HISTORIC AND DESIGN REVIEW COMMISSION

HDRC CASE NO: 2024-155
ADDRESS: 2100 BROADWAY
LEGAL DESCRIPTION: NCB 1763 BLK 33 LOT 1-4, 7-12, P-100-103 & P-105 -106 (PORTION OF CLOSED ALLEY)1
ZONING: IDZ, RIO-1, NCD-9
CITY COUNCIL DIST.: 2
APPLICANT: Ariel Vega/PDI
OWNER: 4M BROADWAY LLC
TYPE OF WORK: Construction of commercial structures and a sub-grade parking structure
APPLICATION RECEIVED: April 12, 2024
60-DAY REVIEW: June 11, 2024
CASE MANAGER: Edward Hall

Broadway BBQ Restaurant

HDRC / OHP
Conceptual Review
San Antonio, TX
April 12, 2024

SITE PLAN
N.T.S.

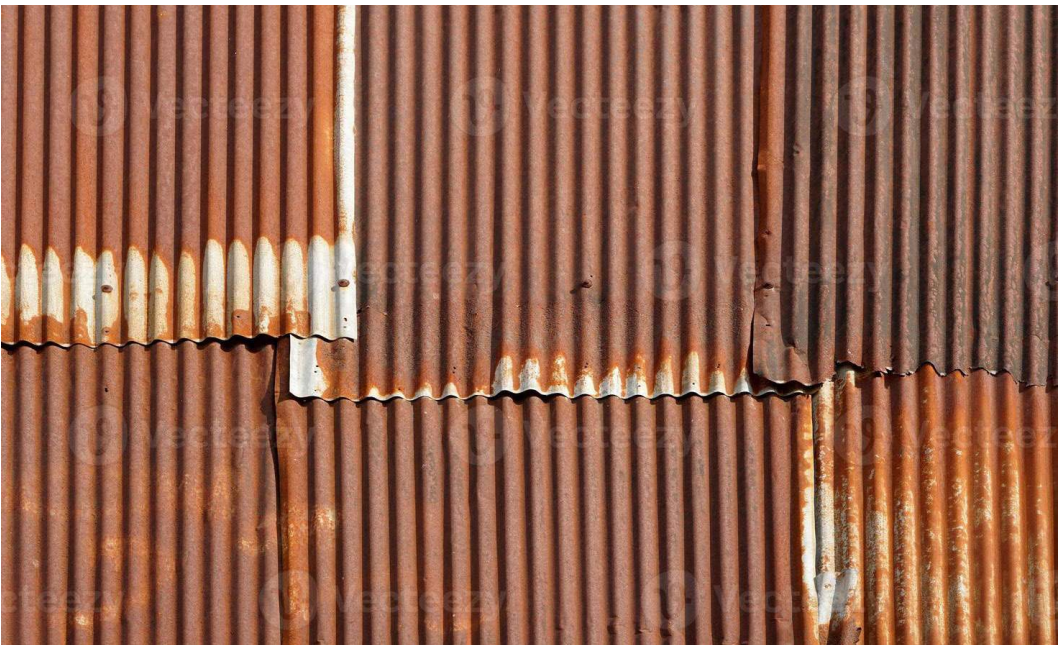
- e. **PEDESTRIAN CIRCULATION** – Per the UDC Section 35-672(a) in regards to pedestrian circulation, an applicant shall provide pedestrian access among properties to integrate neighborhoods. The applicant has proposed sidewalks parallel to the public right of way on Broadway and Alling. Additionally, the applicant has

- i. LANDSCAPING – The applicant has proposed various landscaping elements to be installed throughout the site, including parallel to the right of way on Broadway and Alling and throughout the site's pedestrian oriented elements. Generally, staff finds the proposed landscaping locations to be appropriate. A detailed landscaping plan should be submitted for review and approval when returning to the Commission for final approval. All landscaping elements should be native to the San Antonio region and consistent with the UDC.

- iii. That a detailed landscaping plan should be developed and submitted for review when returning to the Commission for final approval, as noted in finding i.

Pedestrian Safety features at Parking Garage Entry

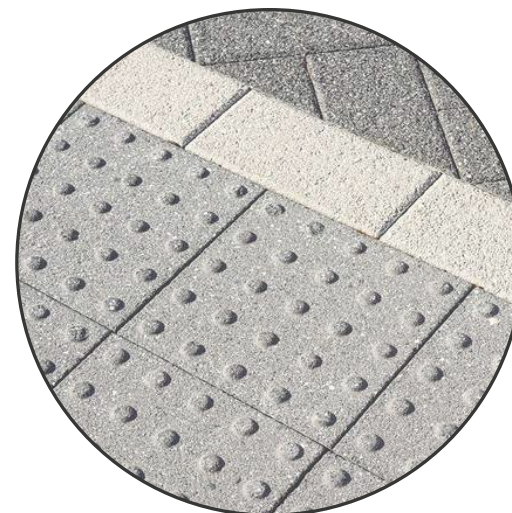
- i. That the applicant incorporate the noted pedestrian safety features at the parking entrance, as noted in finding g, as well as install a landscaped pedestrian between vehicular lanes at the garage's entrance and exit. Additionally, one, uniform grade height across all curb cuts should be considered.

- We are proposing a 10% speed ramp into the garage, and not maxing out the speed ramp (16%), thus creating better sight lines.
- Ability to shift the ramp further toward the east (into the garage) to create more flat driving surface prior to the sidewalk.
- Change in paving pattern
- “Truncated Domes” strip as pedestrian warning device
- Vehicle warning devices
 - Caution Car Coming” sign
 - Audible Alarms
- Convex Mirrors
